Expansion of Lelystad Airport

How to optimize airspace design to accommodate air traffic bound for Lelystad Airport, a study.

*Hadriaan van Nes
KNVvL Study Group Airspace
Version 1.5
Woerden, July 24, 2017*

3. CTR TMA Lelystad voorstel 2014

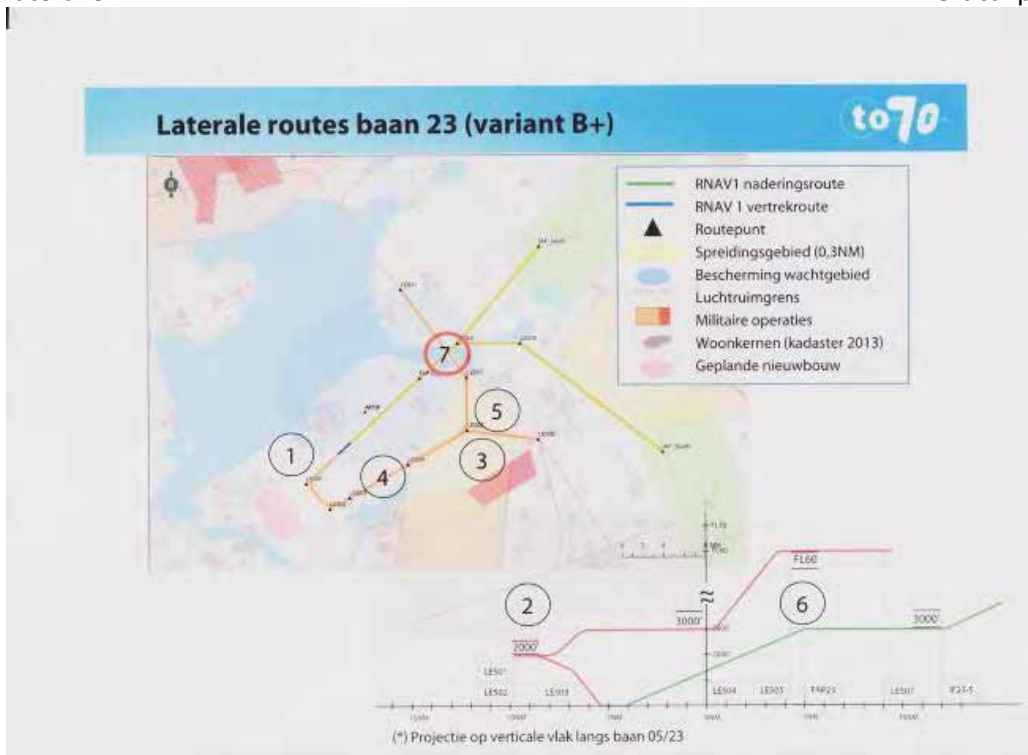
By not consulting the stakeholders in the general aviation beforehand, uncertainty is created by the ministry. The SGA is afraid that a great part of unused airspace remains unused. Airspace that is available to accommodate EHLE traffic. The gliding clubs ACS, ZCNOP and ZCFlevo will face stringent restrictions due to the planned route structure and holding patterns. On an "Alderstafel" sidetrack the gliding club ZCFlevo is in the process of moving their activities towards the main land. The ACS is only mentioned in government documents as a club who still needs to be informed about stringent restrictions, which restrictions is not mentioned. The gliding club ZCNOP is not mentioned at all in any government document.

The size of the EHLE CTR is of great concern as well. Almost the size of the complete polder of Flevoland. This reduces the flying activities of the GA in general and paramotor and paraglide activities West of Zeewolde.

8.

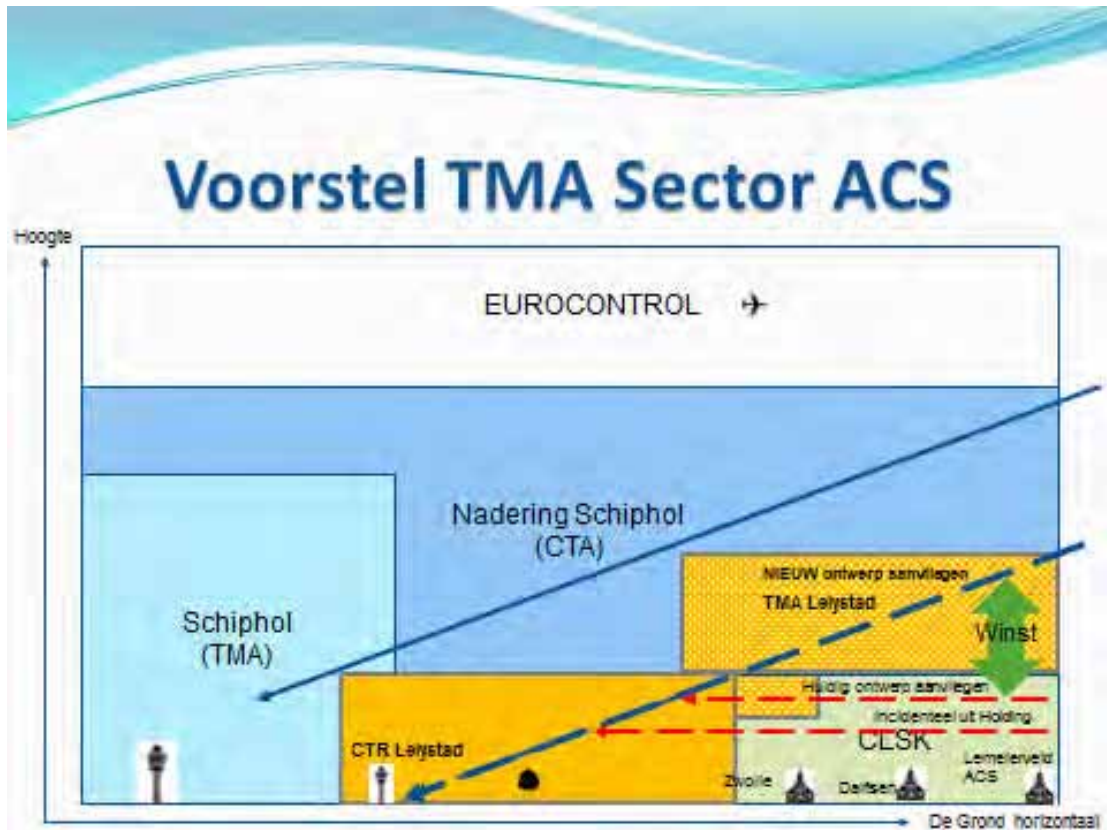
The present route and airspace proposal of the LVNL/CLSK for the CTR/TMA EHLE are unnecessary restrictive and thus undesirable. Especially while taking into account all threats the gliding clubs in this area are facing plus the GA in general.

- Increase the lower altitude of the ARTIP holding pattern by 1000 feet till FL80, this will have no effect on the Schiphol air traffic;
- Create a multi-stage TMA with a lower level of FL65 till the RNAV points OSKUR and NOVEN, West of these RNAV points the lower level will go down till 2500 feet in a multi-stage way; (fig. 8)

- The upper level of TMA EHLE will be at FL115 till the RNAV points NOVEN and OSKUR, West of these points the upper level will descent to FL75 in a multi-stage way;

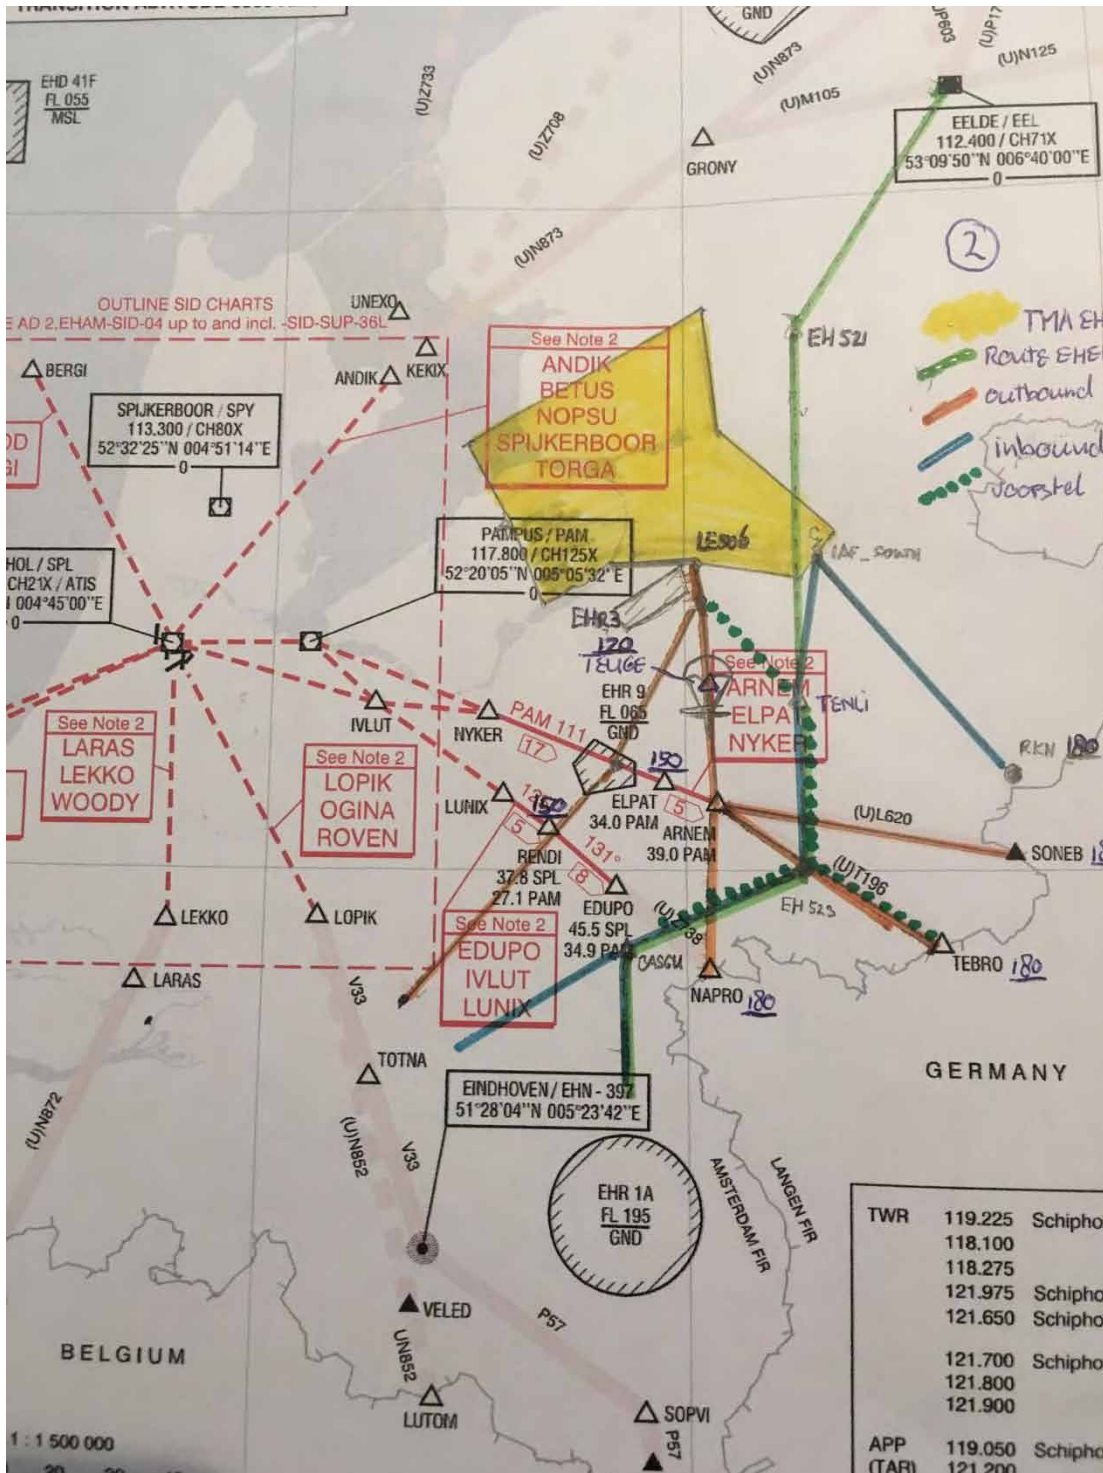
- The proposed routes result in unnecessary low flying for a long period by airliners underneath CTA Amsterdam;
- Air traffic bound for EHLE is the only air traffic which is not allowed to use CTA Amsterdam;

- Air traffic inbound Schiphol is no conflict with outbound EHLE traffic in the direction Southeast;
- Schiphol outbound traffic needs to cross the border with Germany at a sufficient high level so creating plenty of airspace in the area of Deventer-Apeldoorn-Arnhem. Without operational restrictions you can define airspace for arriving and departing EHLE traffic;

- Outbound route "OUT-02" is unnecessarily projected at a low level overhead the airfield of Teuge;
- The proposed maximum flying altitude overhead the RNAV point ARNEM on route "OUT-2" makes it almost impossible for airliners to cross the German border at the MCA of FL180;

- The length of the arrival route IN-02 towards IAF_SOUTH is too short for an approach with normal flying techniques; (Note: Regarding the MCA of FL180 at RKN the profile is perfect for a CDA, including deceleration segments, onto the final approach at EHLE, the approximate crossing altitude at IAF_SOUTH will be FL090

- There is a conflict in the arrival route IN-06 with the departure route OUT-2 and the routes via ARNEM-SONEB plus ARNEM-TEBRO, in altitude, route and airspace.

15. routes proposal area 3

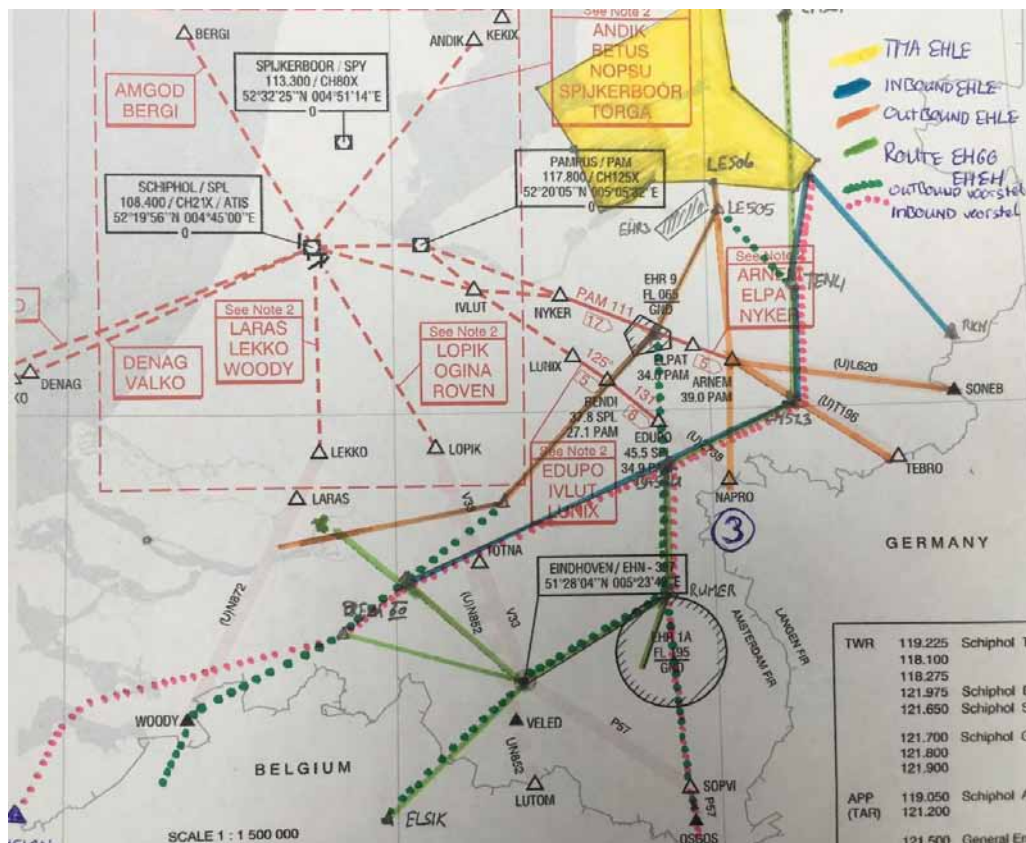
- Air traffic will have to fly along routes OUT-7, OUT-2 and IN-6 through Nieuw Millingen TMA D with a lower level of FL65 and higher level of FL195
- Within TMA Nieuw Millingen a TRA-12 and TRA-12A are situated, military exercise areas.
- All airways but one (UN852 via LOPIK to LNO) are one-way airways.
- There are not many options on connecting routes inbound the Netherlands arriving from the South.
- It is not clear at what level Brussels control accepts Dutch outbound air traffic.
- Route IN-06 is connected to a Southbound only airway UN872 via WOODY.

- Connect route OUT-7 at an higher altitude onto the existing WOODY departure outbound EHEH (and EHAM)
- Create an outbound route via OSGOS onto the OLNO departure outbound EHEH, via RNAV points RUMER and SOPVI.
- Design route OUT-7 via overhead EHEH to join the ELSIK departure outbound EHEH.
- Connect inbound route IN-06 onto inbound boundary point HELEN.
- Create an inbound route via the South via the OLNO arrival to EHEH to connect via RNAV points OSGOS, RUMER and BASGU onto the regular route.
- This creates the following advantages:
 - o More options, less peak traffic
 - o More and better options to connect onto the airways in an early stage.
 - o Less interference with the MME.
 - o More options to accommodate an optimized flightpath without interference of the existing air traffic.

16. Routes north above the Netherlands, area 4

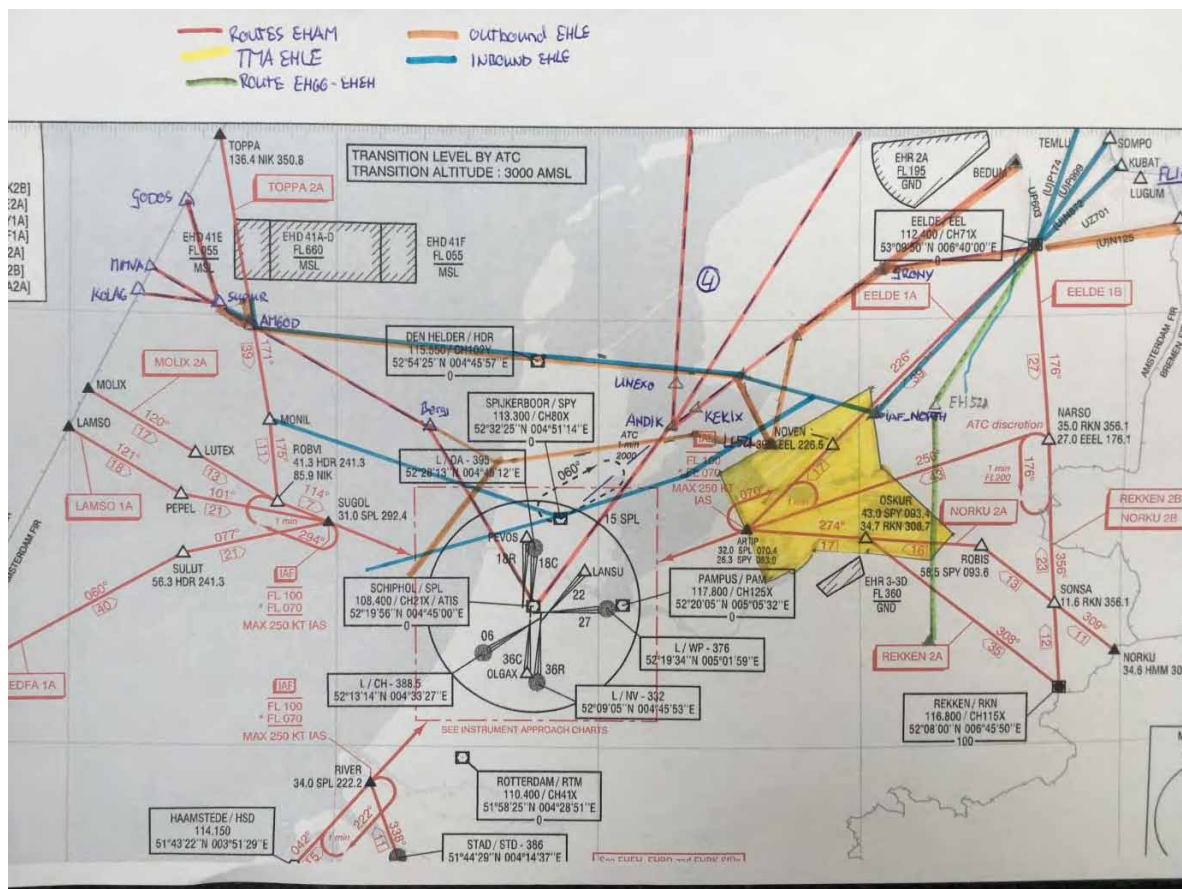
- The route proposal is crossing all kind of traffic above the Province of North-Holland.
- The routes IN-11 and OUT-12 are projected the same and at the same altitude, it is unclear if this is a maximum altitude;
- Routes IN-13 (A&B) are constructed at a realistic altitude along Schiphol through the Schiphol TMA;
- There is a very sharp turn projected in the route IN-11 and IN-13 at IAF_NORTH;
- Approaching and departing traffic to the North via the points EEL and GRONY are via existing routes without interference with other traffic (due to geographic distance between the two airfields);
- No altitudes are defined for route OUT-10 via ANDIK and DENAG;
- It's unclear when air traffic can resume their climb above FL60 on route OUT-1;

- Develop an ARC procedure on the IN-11 and IN-13 with enough altitude to accommodate a CDA onto IAF_NORTH;
- Define a MCA on the departure routes of Schiphol via SPY and ANDIK. The SGA recommends a MCA of FL100 at the RNAV points UNEXO and KEKIX;
- Define a MCA at GRONY of FL180
- In doing so:
 - o Creating space to accommodate optimized flight profiles
 - o Creating an ARC onto IAF_NORTH makes the route and profile more predictable for airliners and air traffic controllers
 - o It is possible to facilitate the minimum flying altitudes on routes OUT-10 and OUT-12 at an higher altitude, in doing so there will be less interference with Schiphol traffic;
 - o It is possible to climb on route OUT-01 with the optimum flight profile.
